Dayton Meeting Minutes

PROJECT: Dayton School District 2019 Bond GS SLC Focus Group

Attachments: Options 1-3

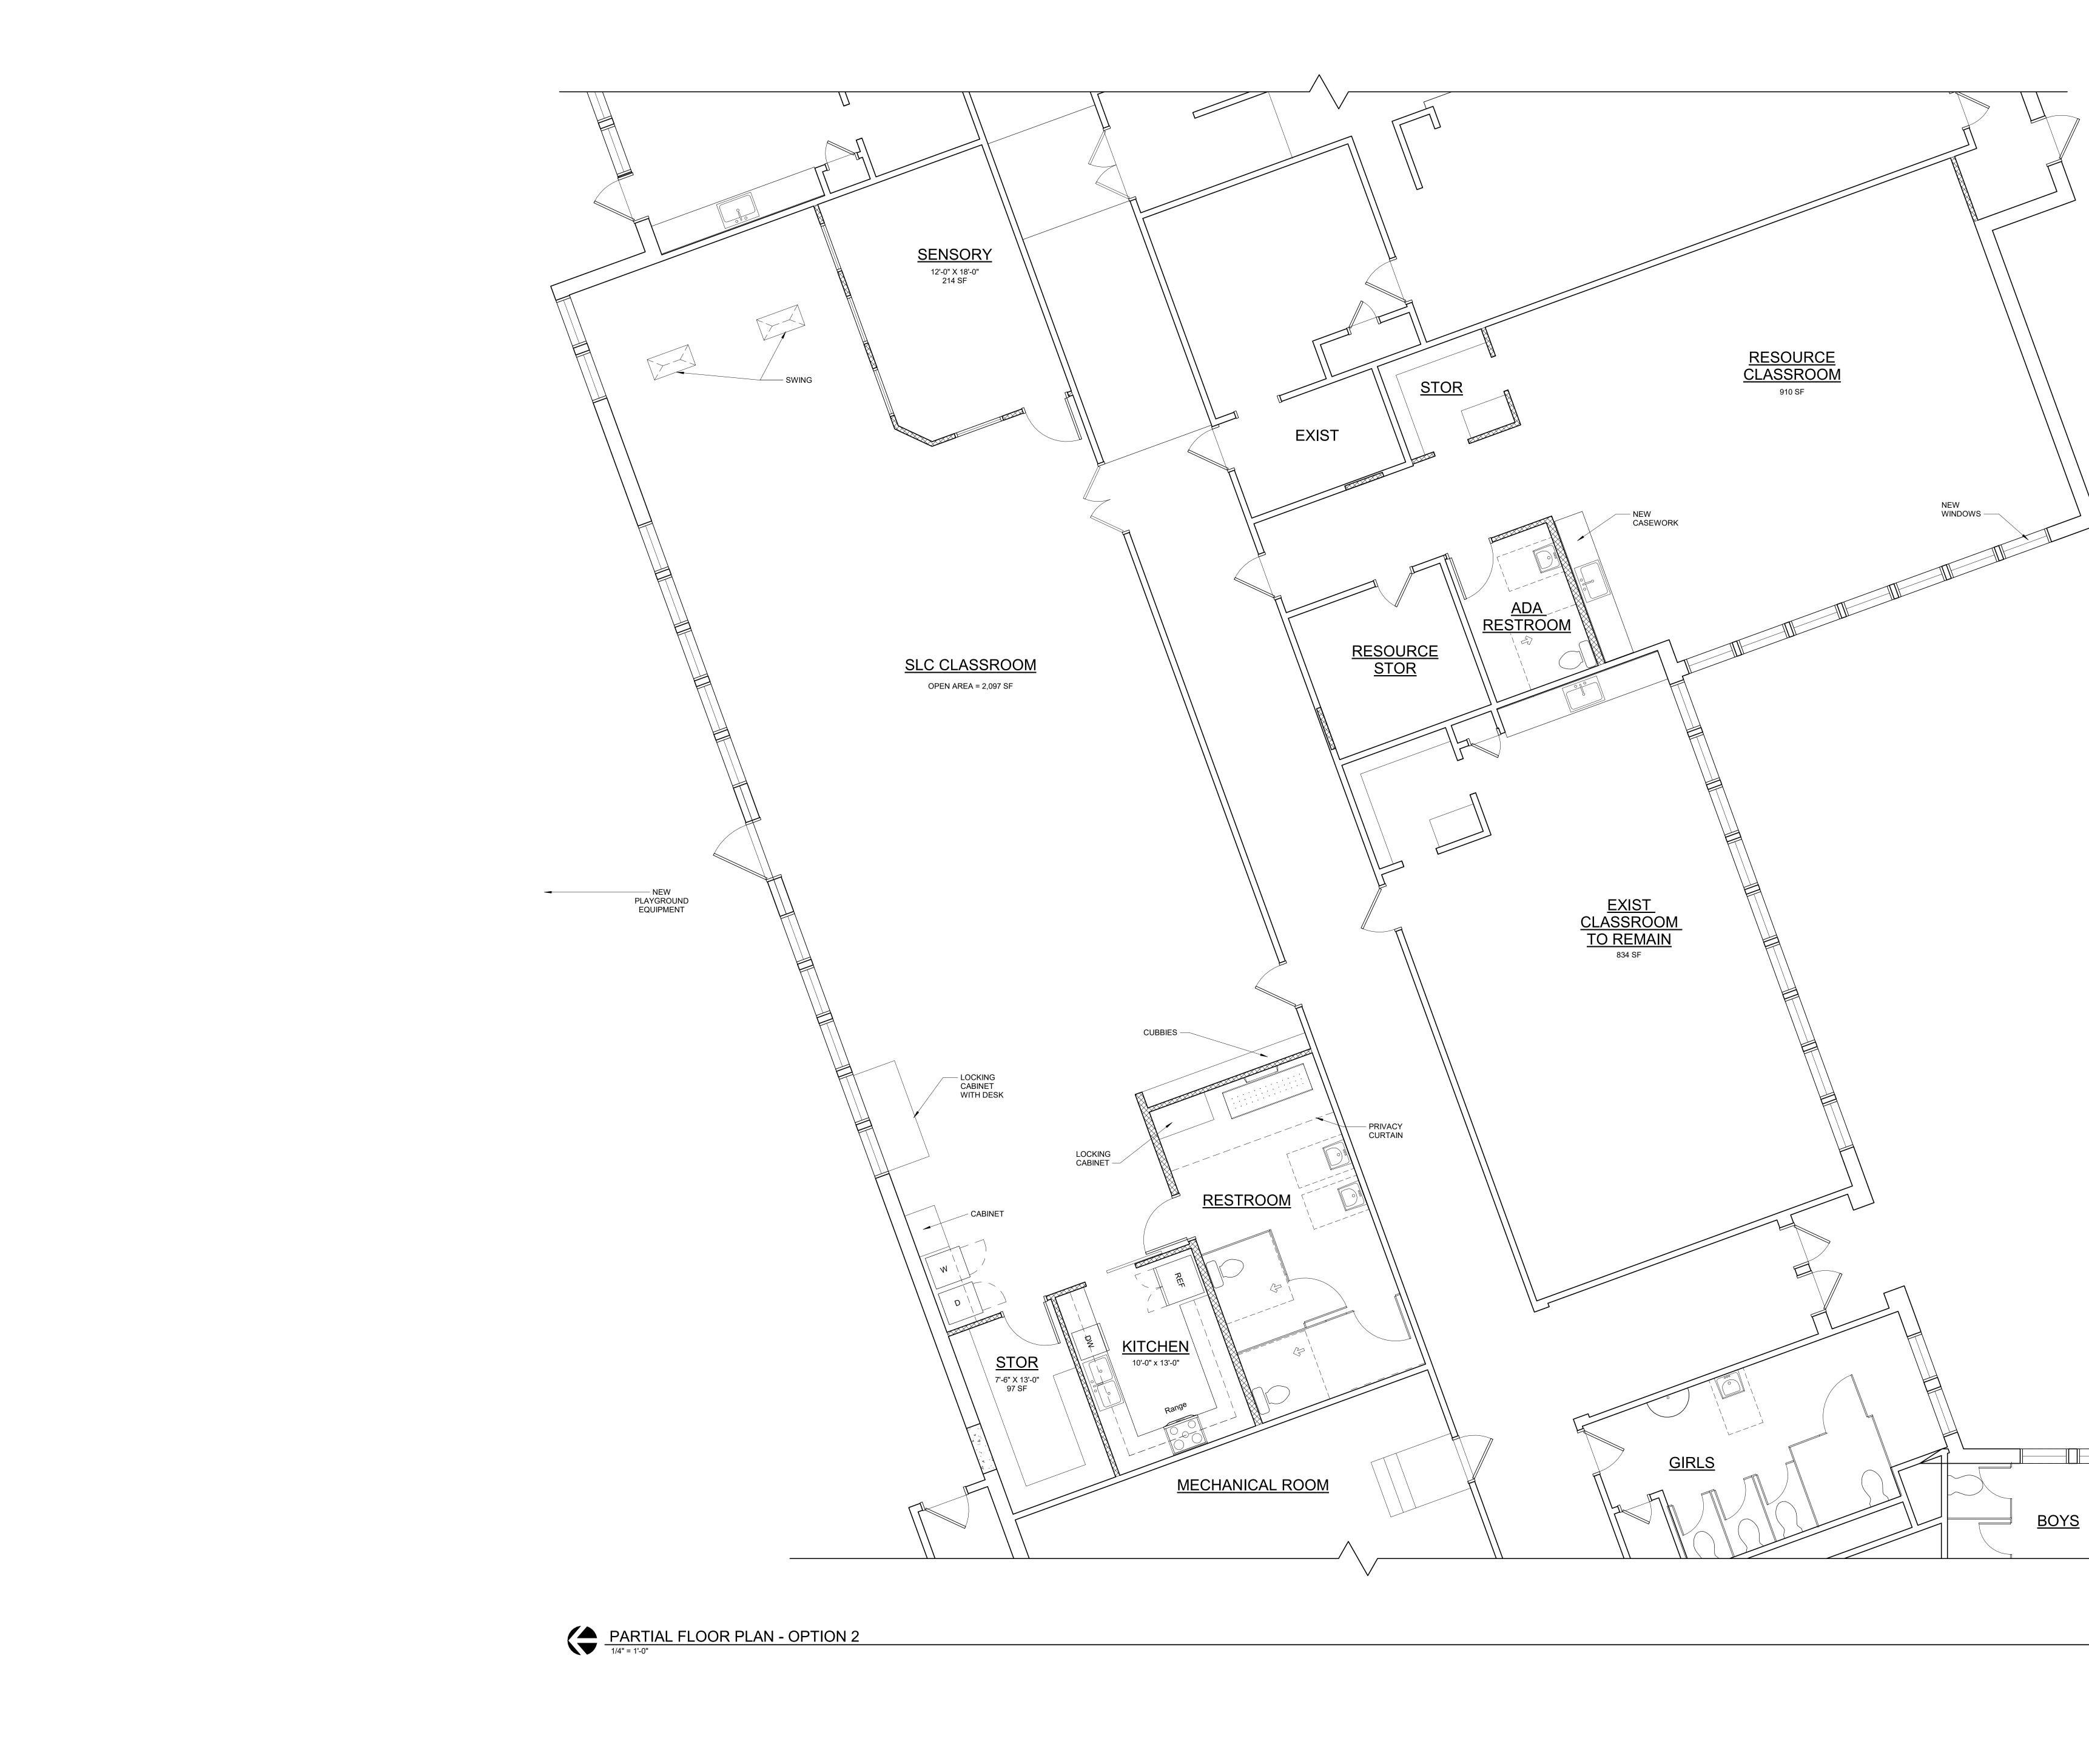
- **1.** Reviewed three design options with group.
 - a. The first two options remodeled the existing SLC space to be more efficient and provide the additional space previously requested. At the existing locker area, a new classroom was created with additional storage. The group liked aspects of both options 1 and 2.

- b. The third option moved the SLC to the existing locker/classroom area in an 'L' shape and made three classrooms out of the SLC space. The classrooms were slightly smaller than average. This option involved disturbing the most square footage and the group opted not to consider this due to cost and awkward layout of SLC.

- 2. A mix of options 1 and 2 were selected for the floor plan.
 - a. From option 1, the group liked the restroom/kitchen/laundry/entry area. However, they preferred the laundry to be located off of the hallway so that resource could also use this. Due to the distance from the exterior wall, this would require a booster pump to vent the dryer.

- b. From option 2, the group liked the sensory/swing area layout. The swing was demonstrated to help provide an idea of what is needed for clearance from the walls. The group also preferred the new classroom layout of option 2, which provides a restroom for this to be a preschool classroom. Additional markups included providing storage rooms for the new classroom and resource classroom.

- c. At the playground area, the existing ramp does not appear to conform to ADA standards and a short wall may be needed to prevent wheelchairs from sliding down the sloping paved play area.

- d. A revised plan will be put together for review.
- 3. Other Considerations
 - a. New windows would not be installed until phase II.
 - b. Electrical capacity still needs to be verified for new equipment.
